# **AUDOBON WOODS SUBDIVISION**

The purpose of this application is to subdivide multiple metes and bounds parcels into 273 lots.

APPLICATION NUMBER 12 DATE June 19, 2003

# DETAIL SITE PLAN

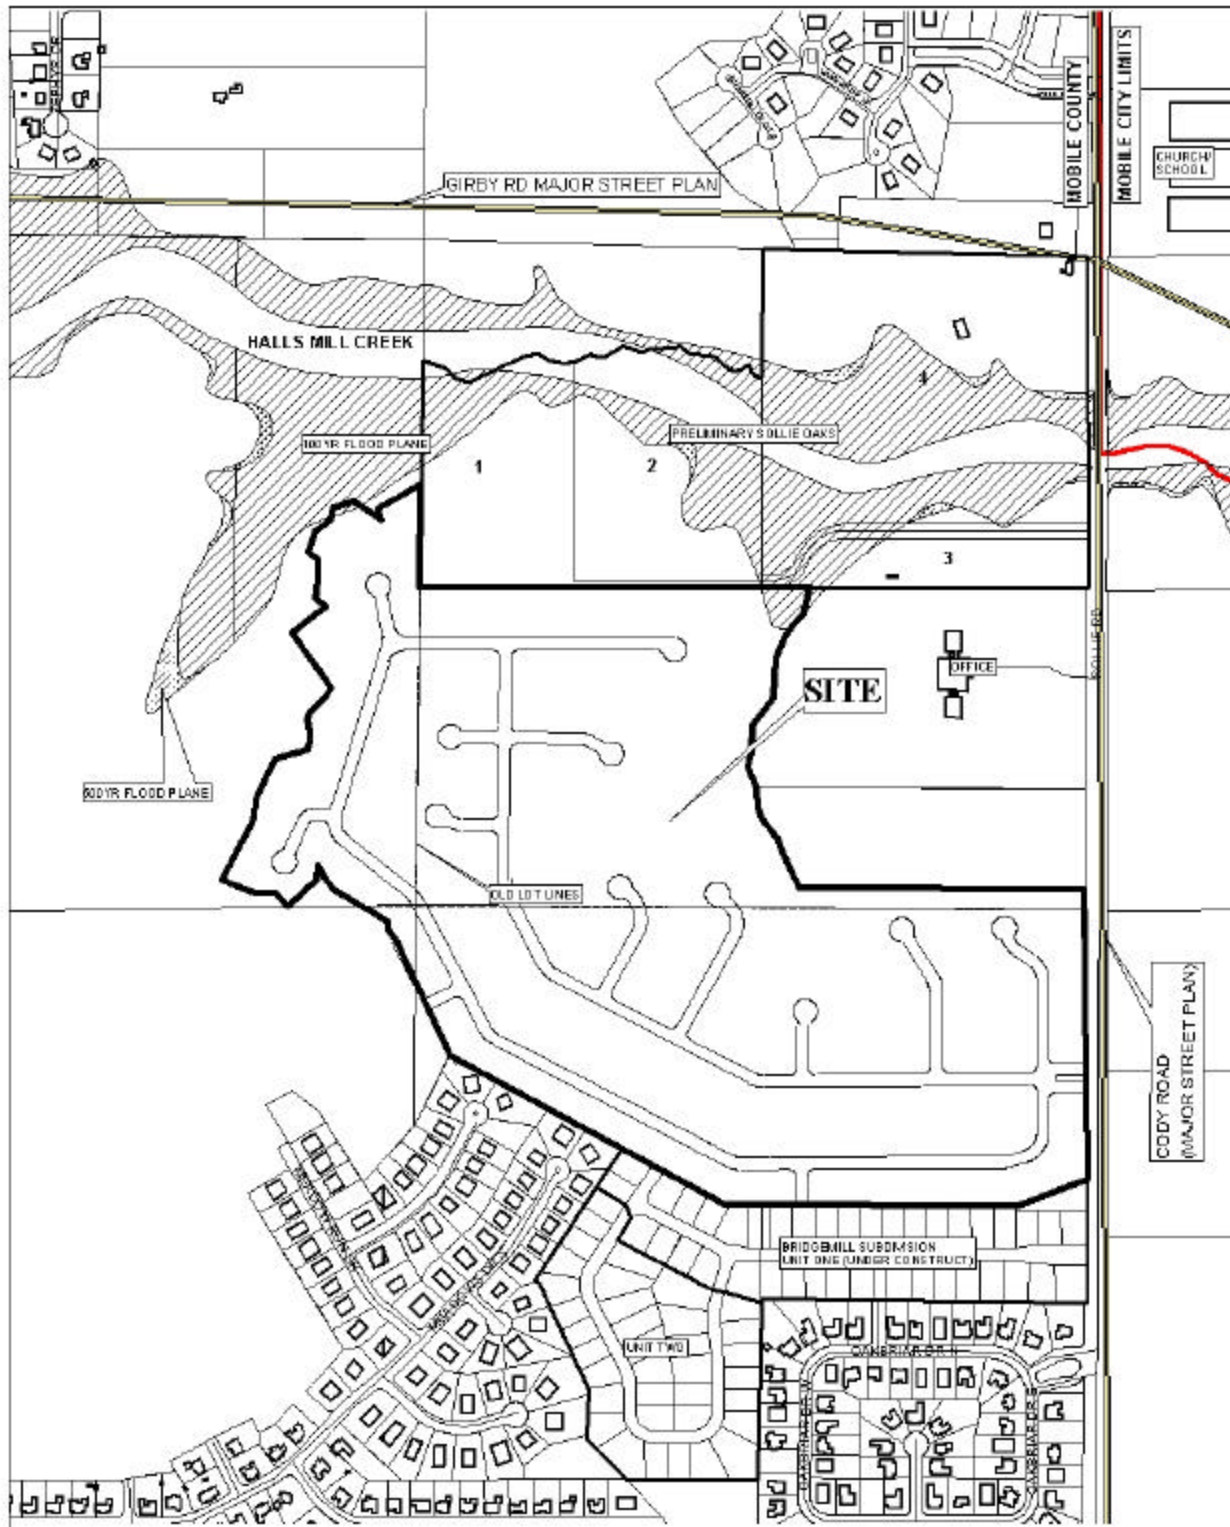
Sollie Road, which has an existing right-of-way of 80-feet, is shown as a major street on the Major Street Plan, and as such requires a 100-foot right-of-way. Therefore, the dedication of sufficient right-of-way to provide 50-feet from the centerline should be required. As proposed, Lots 1-3, and Lots 178-182 have frontage along Sollie Road; therefore, the placement of a note on the final plat stating that Lots 1-3 and Lots 178-182 are denied direct access to Sollie Road, should be required.

The applicant is proposing a street stub between Lots 14 and 15. However, this street stub does not line up with the street stub to the south (Saybrook Subdivision); therefore, the street stub should be placed between Lots 18-24, aligning with the street stub in Saybrook. As illustrated on the Vicinity Map, a street stub to the north would not be required as the Tentative Approval for the subdivision to the north did not provide a street stub. As proposed, the two "long" streets would function as collector streets with no means of cross access. Therefore, the provision of two connecting street stubs, with the location, to be approved by the Land Use Department should be required.

The 25-foot minimum building setback line is not shown but would be required on the final plat.

The plat meets the minimum requirements of the Subdivision Regulations and is recommended for Tentative Approval subject to the following conditions: 1) the dedication of sufficient right-of-way to provide 50-feet from the centerline of Sollie Road; 2) the provision of a street stub between Lots 18-24, to be aligned with the street stub in Saybrook; 3) the placement of a note on the final plat stating that Lots 1-3 and Lots 178-182 are denied direct access to Sollie Road; 4) the provision of two connecting street stubs for the "long" streets, with the location to be approved by the Land Use Department; 5) the obtaining of any necessary approvals of all federal, state, and local agencies; 6) the placement of a note on the final plat stating that if any property is developed commercially and adjoins residentially developed property will provide a buffer in compliance with Section V.A.7. of the Subdivision Regulations; and 7) the placement of the 25-foot minimum building setback line on the final plat.
